Initial feedback from Imtac about Grand Central Station

(January 2025)

This paper provides feedback from Imtac about the first phase of the opening of Grand Central Station in Belfast. The feedback reflects previous recommendations on the project and is informed by experience with several previous Translink projects and developments. This includes written comments provided by the Committee at different stages of the design of the project in 2017¹ and then 2020². It also includes specific engagement that has taken place between Translink and Imtac around signage, tactile surfaces, seating and visual information screens. The final consideration was a site visit to the new station involving Imtac members on the 25th October 2024 and other feedback / comments made by the general public.

Appendix A – Lift provision at London Bridge Station & Grand Central

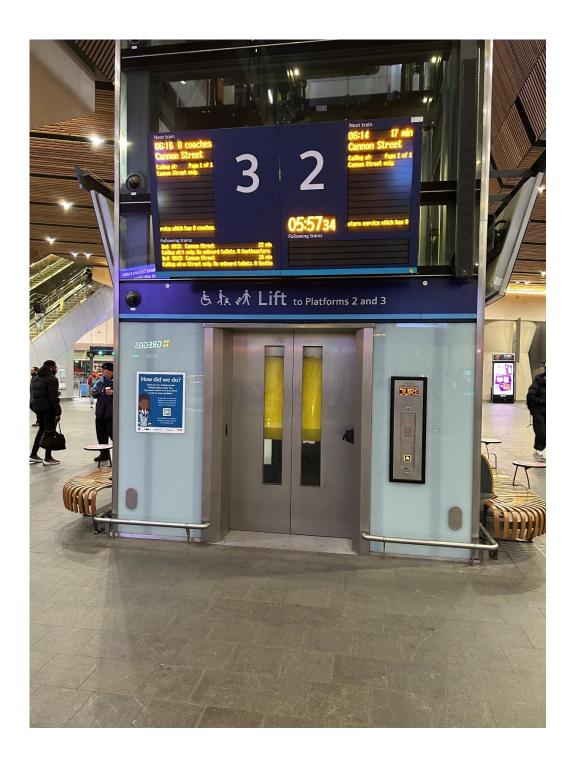
The image above shows lift provision at London Bridge Station. The potential barriers created by use of chrome and glass are mitigated by using white glass surrounding doors and controls, ensuring passengers can identify these more easily. Signage above the lift further assists passengers identify entrance to the lift.

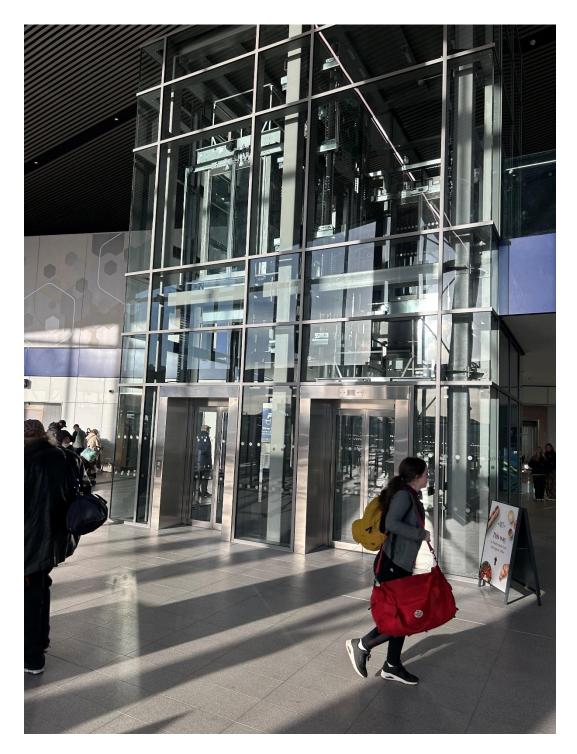
Access to the mezzanine level from the ground floor is via two lifts, escalators and stairs. The main issue with these facilities is the poor use of contrasting materials. The predominant use of chrome and glass materials for the lifts makes identifying entrances and exits and lift controls difficult particularly on the ground floor. Using a colour on the surrounding glazing, as used at stations such as London Bridge, could make the doors and lift controls more identifiable. Appendix A has photographs that illustrate this issue.

This image above from Grand Central illustrates how the predominant use of glass and chrome makes identification of the lift doors and controls more difficult for some passengers. Visibility strips, using white dots have been provided but do little to help differentiate between doors and the surrounding areas. Signage above lift doors could help make these entrances more identifiable.
